# Access Compliance Report

## Public Rights-of-Way

Intersection ID: 52956	Main Street: OLD_POST_RD	Cross Street: CONFERENCE_DR	Location: E
ADA ID: 569A44D26C1F	Ramp Type: PerpDiag	Initial Pass/Fail: Fail	Overall Compliance: No
Severity Score: 21.25			
Codes/Mitigation Info/Possible Solution		Field Measurements/Component Compliance

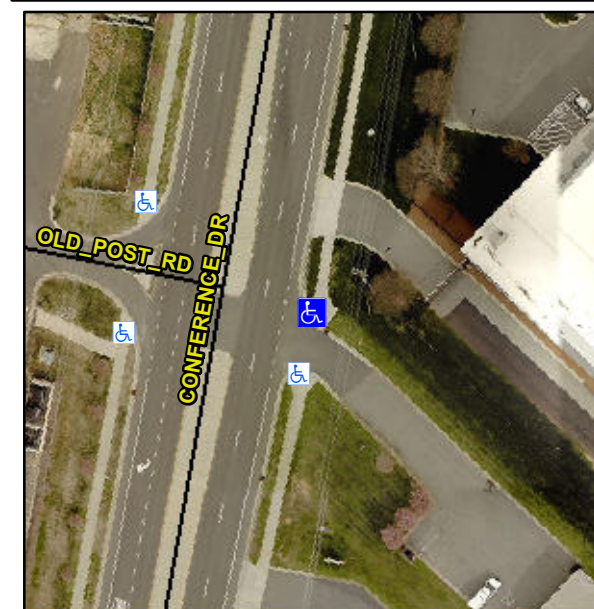
**Not Found, R304.5.1, R304.5.3**

Compliance	Description	Data	Compliance	Description	Data
N/A	Ramp Length (in)	66.0	Yes	Ramp Slope (%)	6.3
No	Ramp Width (in)	47.5	No	Ramp XSlope (%)	5.4
N/A	Flare Type LT	N/A	N/A	Flare Type RT	N/A
N/A	Flare Slope LT (%)	N/A	N/A	Flare Slope RT (%)	N/A
N/A	Flare Traversable LT?	N/A	N/A	Flare Traversable RT?	N/A
N/A	Landing Length (in)	N/A	N/A	DWS Provided?	N/A
N/A	Landing Width (in)	N/A	N/A	DWS Contrast?	N/A
N/A	Landing Slope (%)	N/A	N/A	DWS Length (in)	N/A
N/A	Landing X Slope (%)	N/A	N/A	DWS Full Width?	N/A
N/A	Landing Curb? (Y/N)	N/A	N/A	DWS Offset (in)	N/A
N/A	Shared Landing?	N/A			
N/A	Gutter Ponding?	N/A	N/A	Gutter Slope (%)	N/A
N/A	Gutter Lip Ht (in)	N/A	N/A	Gutter X Slope (%)	N/A
N/A	Painted X Walk1?	No	N/A	Painted X Walk2?	No
	X Walk 1 Direction	To W		X Walk 2 Direction	To SW
N/A	X Walk 1 Width (in)	N/A	N/A	X Walk 2 Width (in)	N/A
	X Walk 1 Slope (%)	2.9		X Walk 2 Slope (%)	2.8
	X Walk 1 X Slope (%)	1.2		X Walk 2 X Slope (%)	3.4

**Remove & Replace Curb Ramp With Two New Directional Ramps or Equivalent.**
